Service Bulletin 180012

3xLOGIC - VISIX VX-4V28-OD-I - WDR Failure - Fix

Service Bulletin #:	180012-1
Date:	April 30th, 2018
Product Affected:	3xLOGIC VISIX VX-4V28-OD-I Camera with R6 V5.4.1 Firmware
Purpose:	This bulletin is intended to inform users of a fix for a recently discovered issues causing WDR to fail on VX-4V28-OD-I cameras when using certain image resolutions.
*Importance:	Low

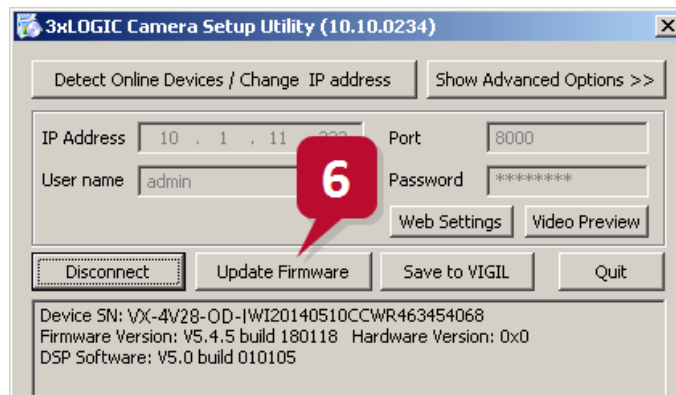
3xLOGIC Engineering has recently identified an issue in VISIX VX-4V28-OD-I cameras with firmware R6 v5.4.1. When the the R6 v5.4.1 firmware is installed, the camera's Wide Dynamic Range (WDR) feature will fail when used in conjunction with the camera's substream if any resolution other than 352X240 is being used. Due to technical limitations, substream must be set to its lowest resolution to maintain WDR functionality.

In order to use high resolution sub-stream with WDR, the camera firmware must be updated to v5.5.0. This update will disable All-in-One functionality and prevent downgrading the camera firmware, but will allow the simultaneous use of WDR and higher-resolution sub-stream. To install this firmware:
